**Sling Aircraft (Pty) Ltd**  
**Registration no 2002/022837/07**  
 Approved Maintenance Organisation AMO1264  
 Manufacturing Organisation M677

**SERVICE BULLETIN**

#0020 Revision 1

**SUBJECT:** Eyebolt inspection and conditional replacement

Figure 3: Type 3 Eyebolt

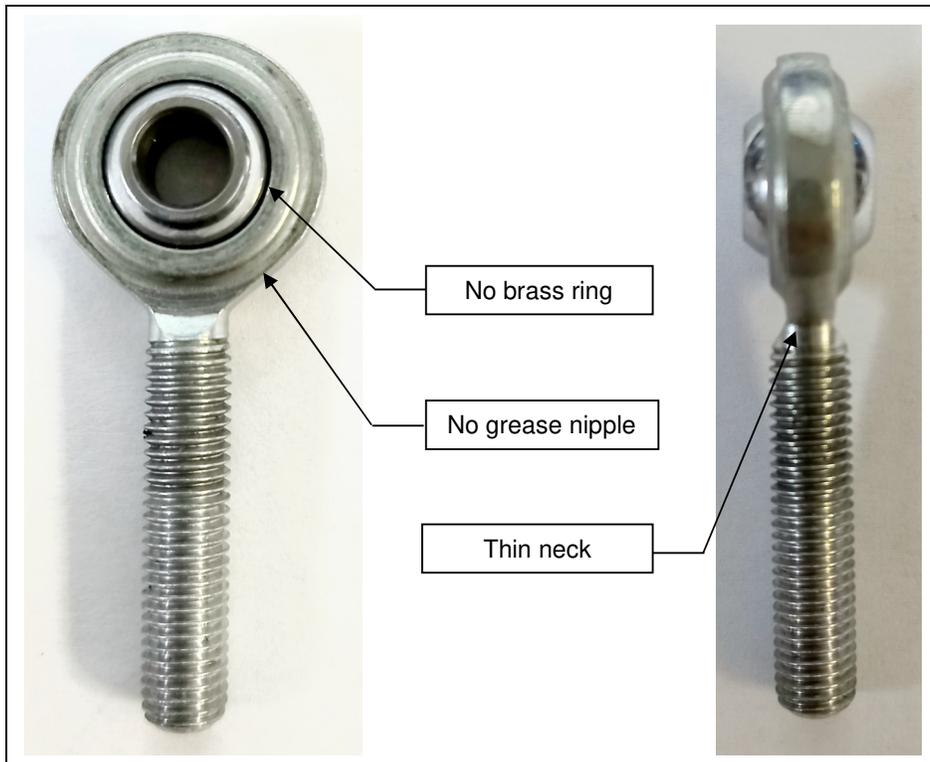
All aircraft will need to be inspected during the next MPI (or annual inspection, whichever is reached first). If it is found that *type 3* or *type 4* eyebolts have been supplied and used, they must be replaced with either *type 1* or *type 2*. Any kits still under construction will need to be inspected and required replacements must be made before the aircraft's first flight.

As seen below, the main difference between *type 3 and 4*, and the other two eyebolt types is the brass ring and shape of the neck of the eyebolt.

Figure 5: Rudder and Nose Wheel Controls

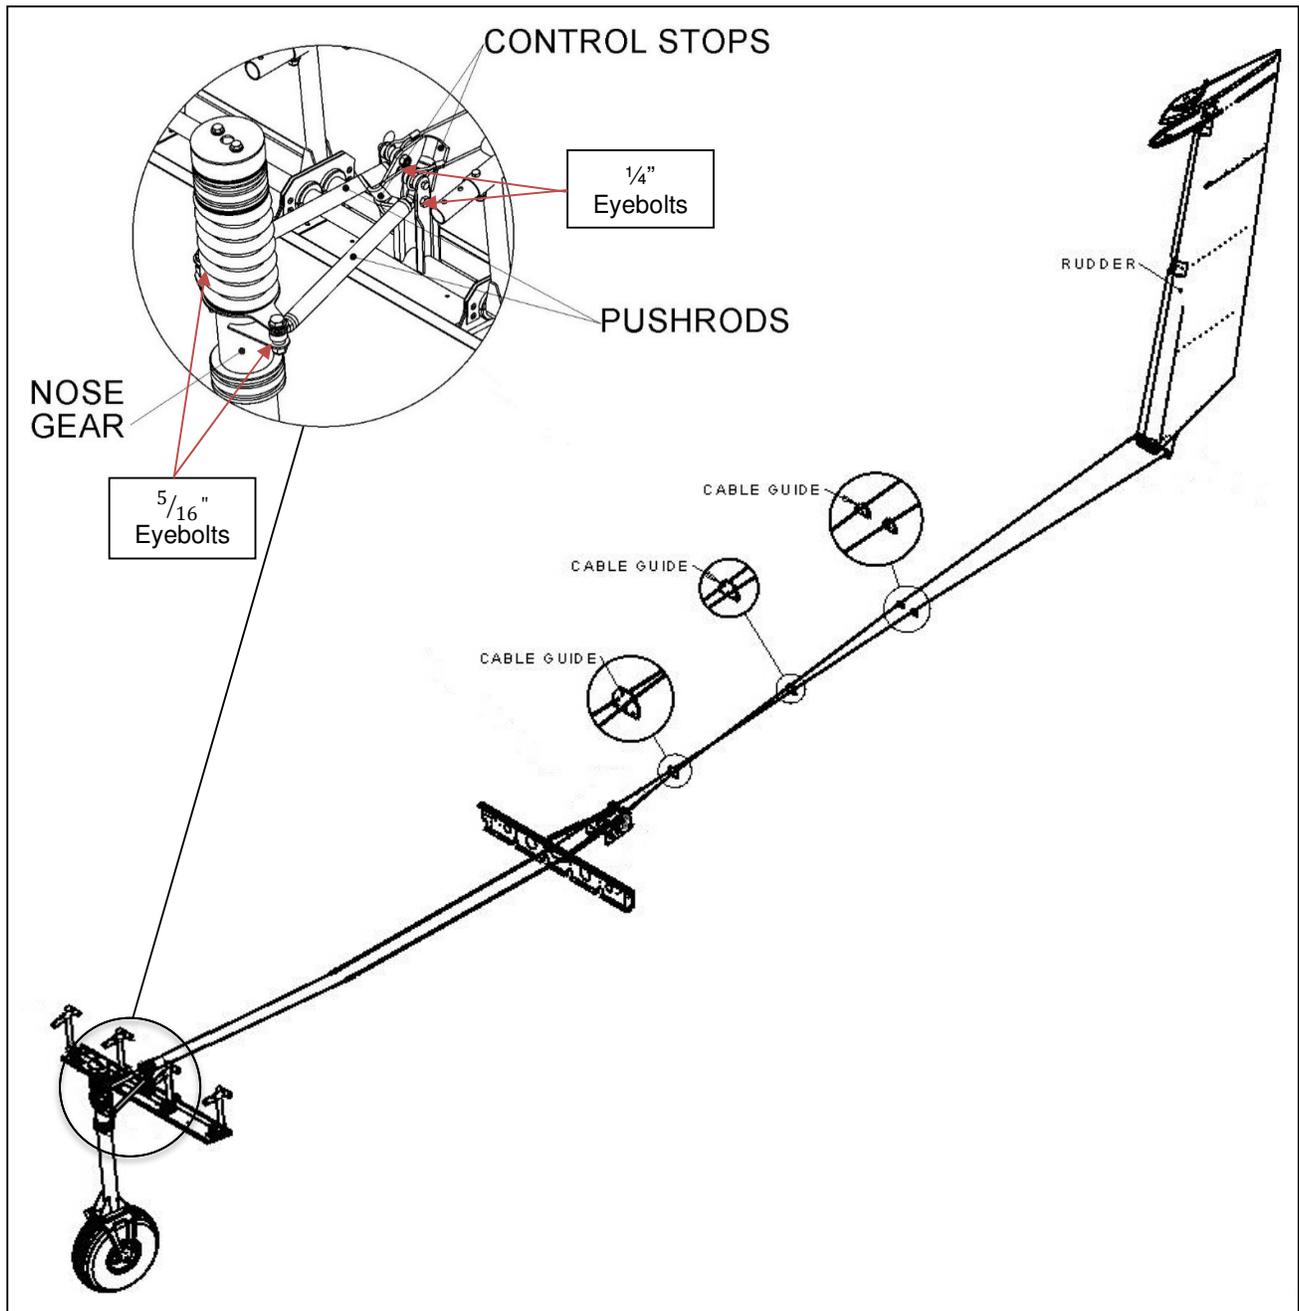
The eyebolts used in the rudder and nose wheel control arm assembly can be seen in Figure 5. The eyebolts need to be inspected and replaced where *noncompliant* eyebolts have been installed.

Step 4. Install new 5/16" eyebolts, either a *type 1* or *type 2* eyebolt, on the pushrods. To do this, reverse the procedure performed in Step 1.

Step 6. Replace the 1/4" eyebolts with the correct type (either *type 1* or *type 2* may be used), reinstall them onto the pushrod and connect them to the rudder pedal assembly once more. Refer to Figure 6 for the way in which the components fit together.

Figure 6: 1/4" eyebolt rudder pedal assembly

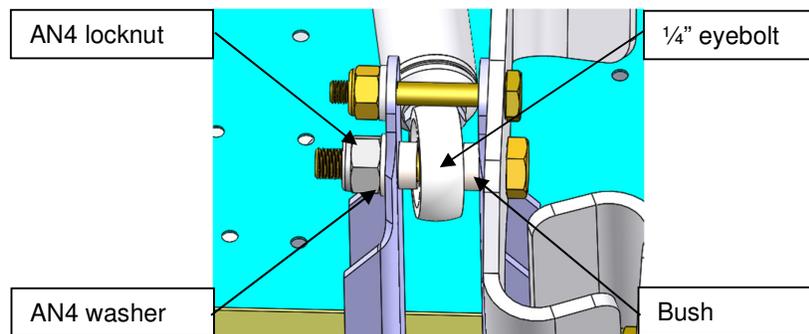
Step 5. Remove the 1/4" eyebolts, these are located on the rudder pedal assembly as shown in Figure 5, and can be accessed from inside the cabin. By referring to Figure 6, remove the AN4 locknut and AN4 bolt. The 1/4" eyebolt can now be uninstalled from the pushrod.

Figure 7: Aileron Controls

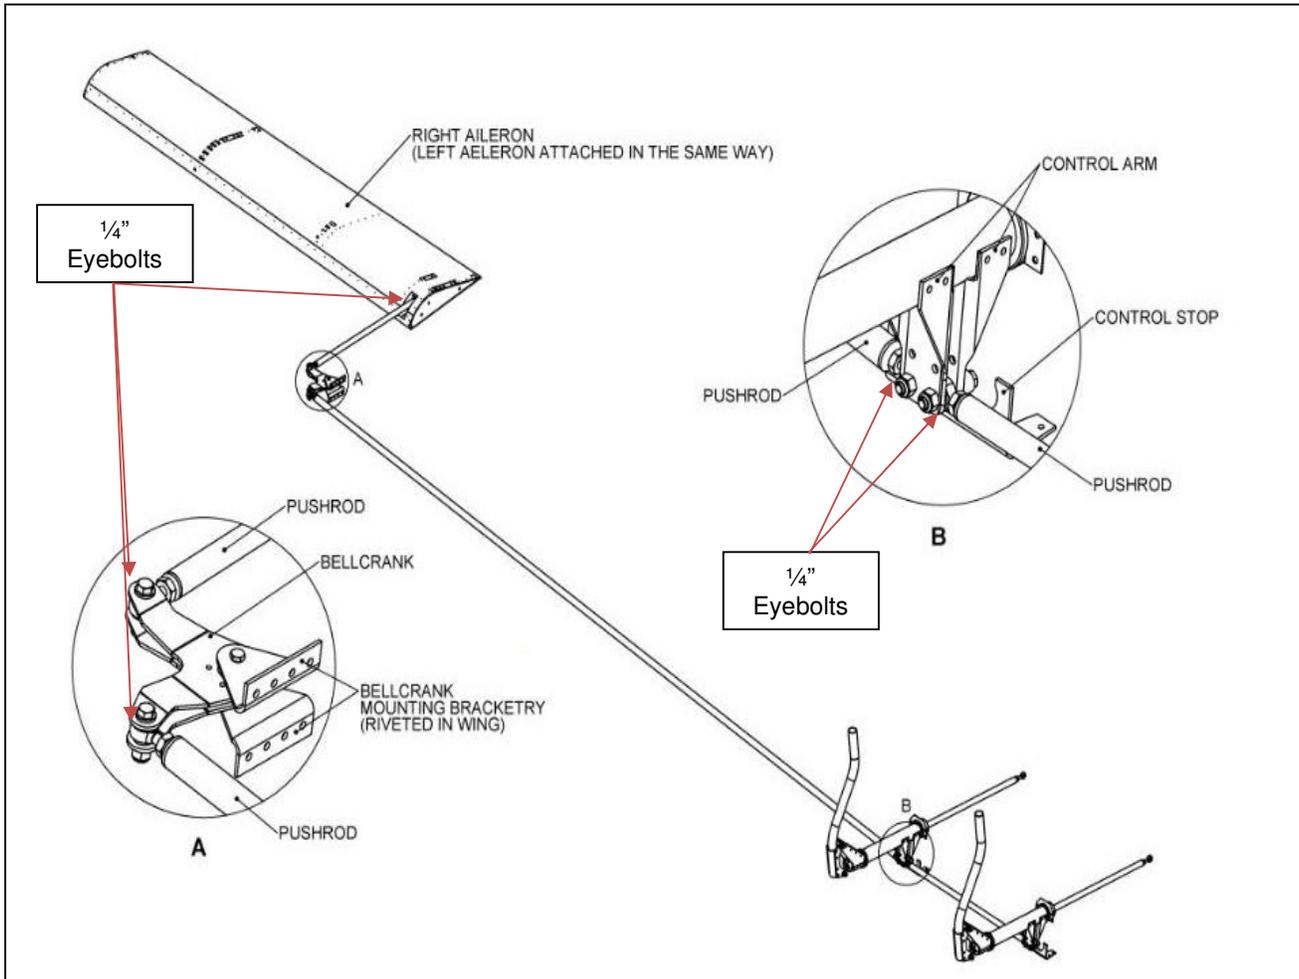
The eyebolts used in the aileron control assembly can be seen in Figure 7. These can be inspected using the inspection hatches located on the wing. Due to symmetry only one aileron has been shown. The same eyebolts will be found on the other side of the aircraft. The eyebolts need to be inspected and replaced where *noncompliant* eyebolts have been installed.

- Step 2. Ensure both eyebolts that are connected to the control arm in Detail B are replaced, with either a *type 1* or *type 2* eyebolt, if *noncompliant* eyebolts have been used.
- Step 3. Reverse the procedure in Step 1 to reinstall the eyebolt assembly.
- Step 4. To replace the eyebolts seen in Detail C of Figure 8, remove the AN4 locknut (13) and bolt (16). The eyebolt should now be uninstalled from the pushrod (5). A *type 1* or *type 2* eyebolt should then be installed on the pushrod.

Figure 9: Aileron bell-crank assembly

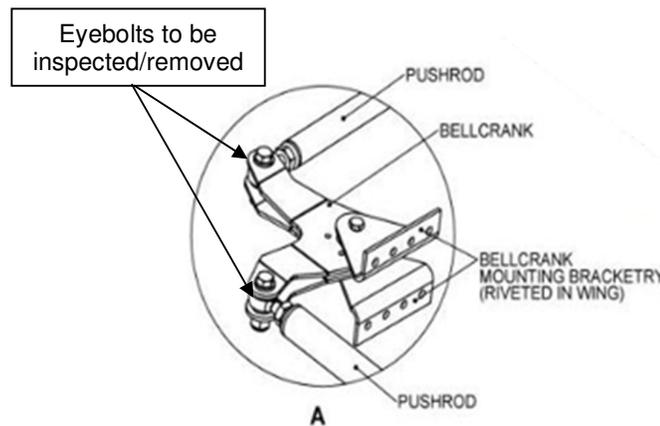
- Step 9. Refer to Figure 9 and remove the AN4 locknuts and bolts.
- Step 10. The eyebolts can now be removed and replaced with either *type 1* or *type 2* eyebolts, if required.
- Step 11. Reinstall the eyebolts to the bell-crank assembly, by reversing the procedure in Step 9 . Refer to the installation procedure in the manual shown in the table below for component placement:

Figure 10: Aileron leading edge eyebolt assembly

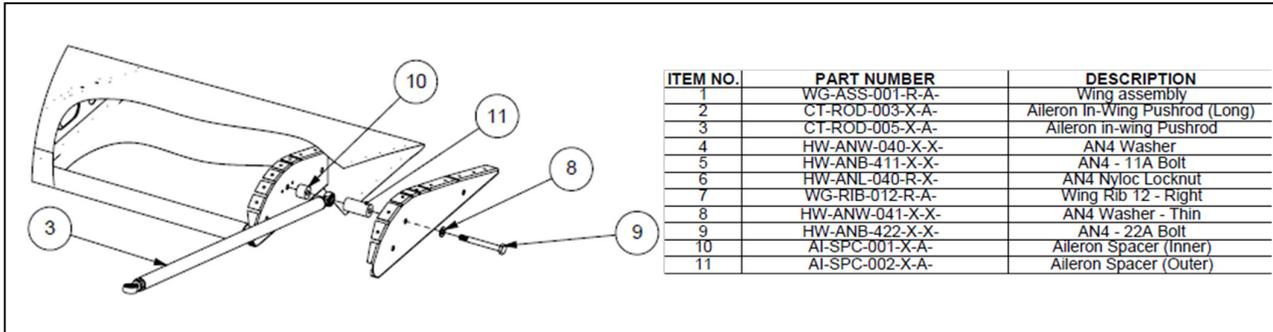
Step 13. For the eyebolts located at the ailerons leading edge, remove the AN4 bolt (9) shown in Figure 10. To access this bolt, you will need to drop the flap. To do this follow steps 1 and 2 *only*, of the flap removal procedure (Option1). This procedure can be found in the applicable MAM shown in the table below. Remember to support the flap during this step as it may drop.

- Step 14. After bolt (9) has been removed, the eyebolt can be replaced with either a *type 1* or *type 2* eyebolt. Reconnect it to the aileron and pushrod (3), as shown in Figure 10. Support the aileron during this step as it may drop once the eyebolt has been removed.
- Step 15. Reattach the flap by reversing the procedure followed in Step 13.
- Step 16. Repeat Step 9 to Step 15 to remove the eyebolts used in the aileron control assembly on the other side of the aircraft.
- Step 17. You will need to adjust the ailerons once the new eyebolts have been installed, to ensure correct aileron deflection. To do this, follow the instructions in the applicable MAM shown in the table below:

Figure 11: Aileron Controls

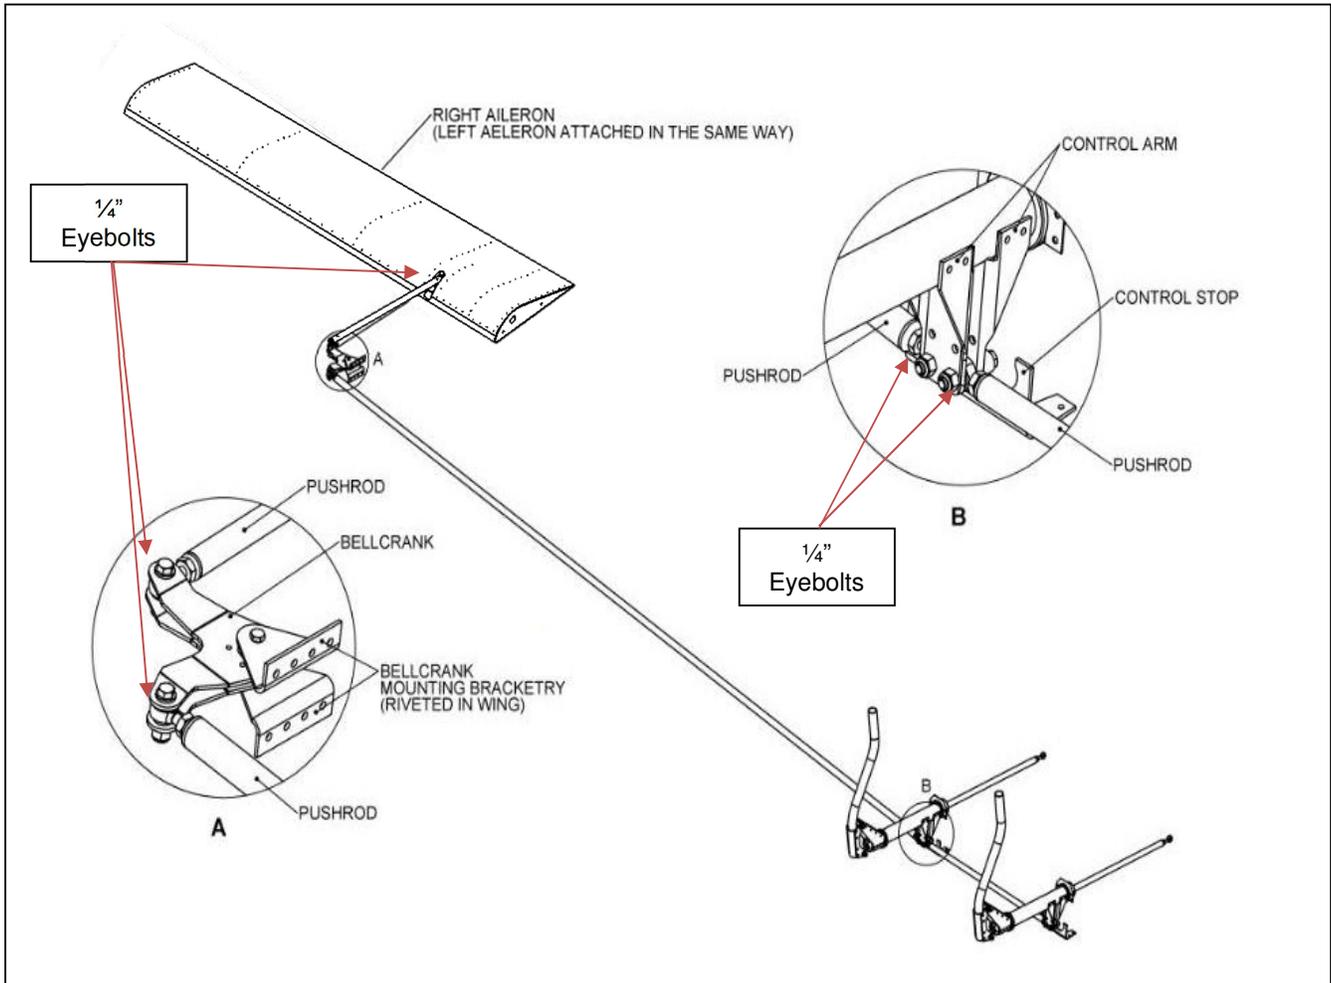
The eyebolts used in the aileron control assembly can be seen in Figure 11. These can be inspected using the inspection hatches located on the wing. Due to symmetry only one aileron has been shown. The same eyebolts will be found on the other side of the aircraft. The eyebolts need to be inspected and replaced where *noncompliant* eyebolts have been installed.

- Step 2. A *type 1* or *type 2* eyebolt should then be installed in place of the *noncompliant* eyebolt, if required. Ensure both eyebolts that are connected to the control arm in Detail B are replaced, if *noncompliant* eyebolts have been used.
- Step 3. Reverse the procedure in Step 1 to reinstall the eyebolt assembly. Do not replace the seats and control covers that were removed in Step 1 until the required eyebolts shown in Section 3.2.6 have been inspected and replaced, if required.

Figure 12: Eyebolt assembly, Detail C

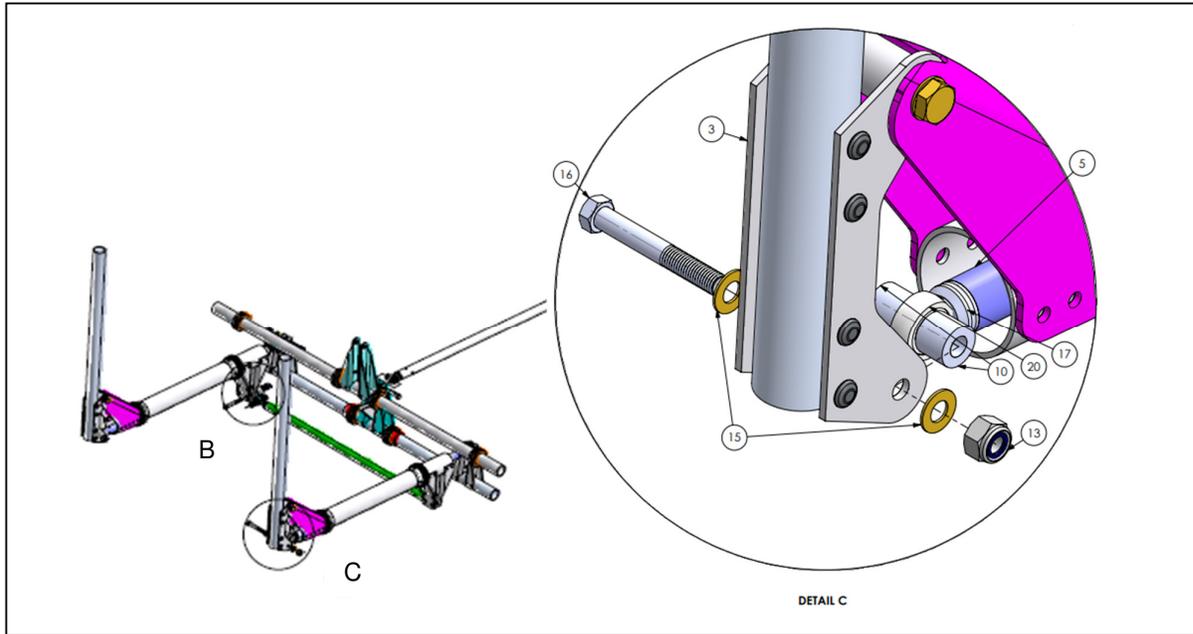
- Step 4. To replace the eyebolts seen in Detail C of Figure 12, remove the AN4 locknut (13) and bolt (16). The eyebolt should then be uninstalled from the pushrod (5). A *type 1* or *type 2* eyebolt should then be installed on the pushrod.

- Step 5. Reassemble the eyebolt assembly by reversing the procedure in Step 4, refer to Figure 12 for component placement.
- Step 6. The eyebolts used in the aileron bell-crank also need to be inspected and replaced if *noncompliant* eyebolts have been installed. These must be replaced with either *type 1* or *type 2* eyebolts. Remove the outboard inspection hatches on both wings, to expose the bell-cranks.

Figure 13: Aileron bell-crank assembly

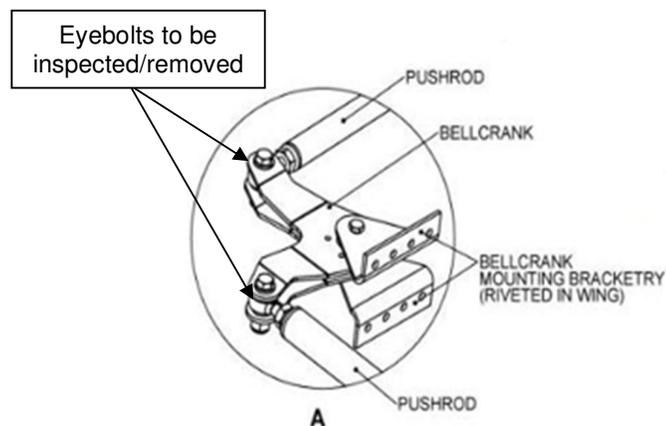
- Step 7. Refer to Figure 13 and remove the AN4 locknuts and bolts.
- Step 8. The eyebolts can now be removed and replaced with either *type 1* or *type 2* eyebolts, if required.

Figure 14: Aileron leading edge eyebolt assembly

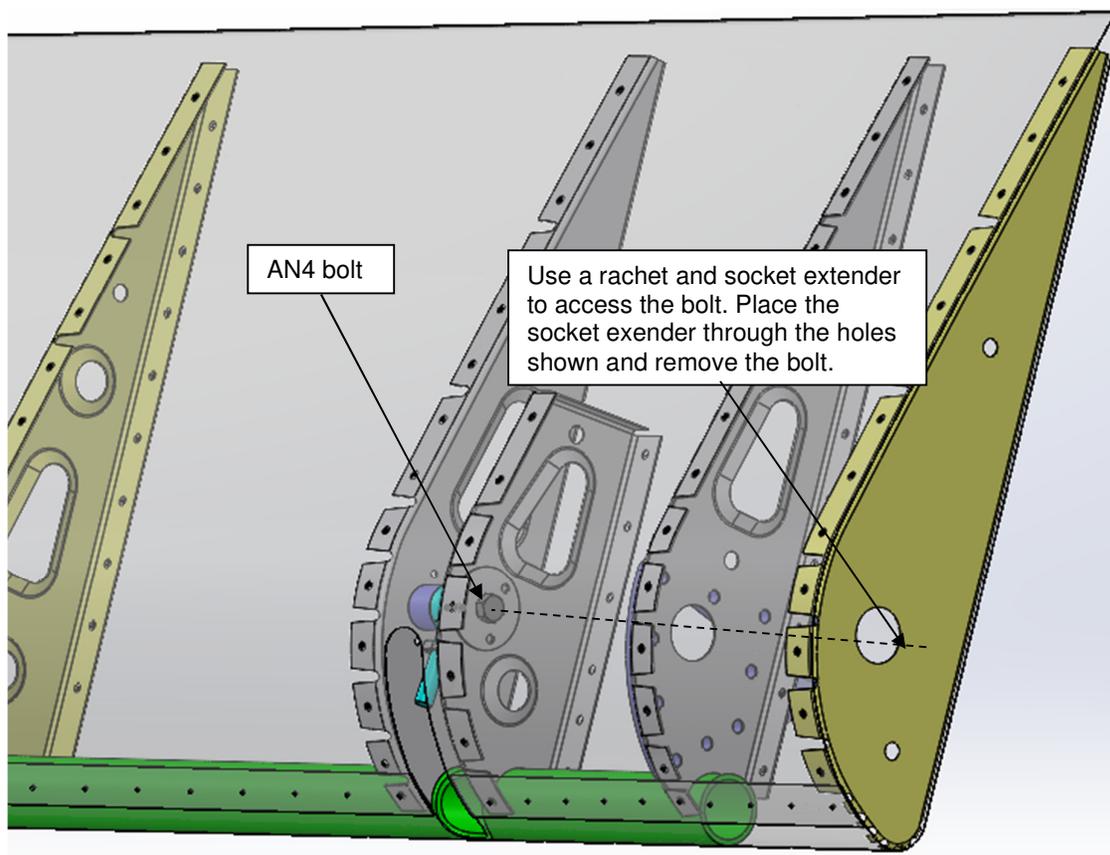
Step 11. For the eyebolts located at the ailerons leading edge, remove the AN4 bolt (9) shown in Figure 14. To access this bolt, you will need to drop the flap. To do this follow steps 1 and 2 *only*, of the Flap removal procedure (Option1). This procedure can be found in Section 4.1.3.2 of manual DC-MAM-001-X-F. Remember to support the aileron and flap during this step as they may drop.

Figure 15

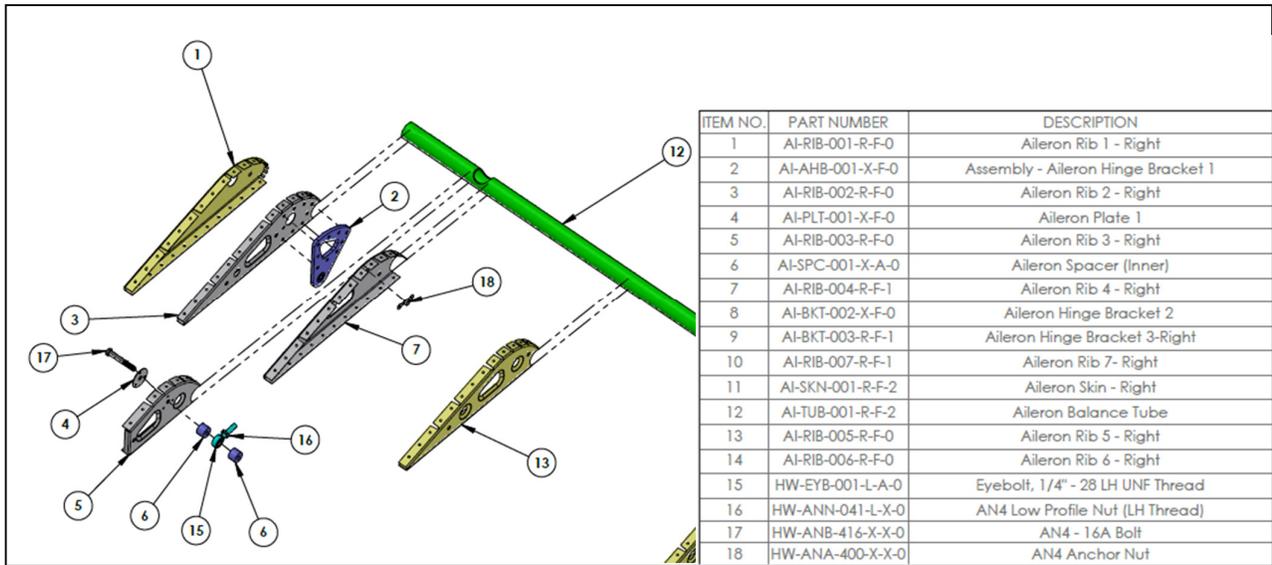
Step 12. After the bolt has been removed, the eyebolt can be replaced with either a *type 1* or *type 2* eyebolt. It should then be reconnected to the aileron and pushrod, as shown in Figure 15.
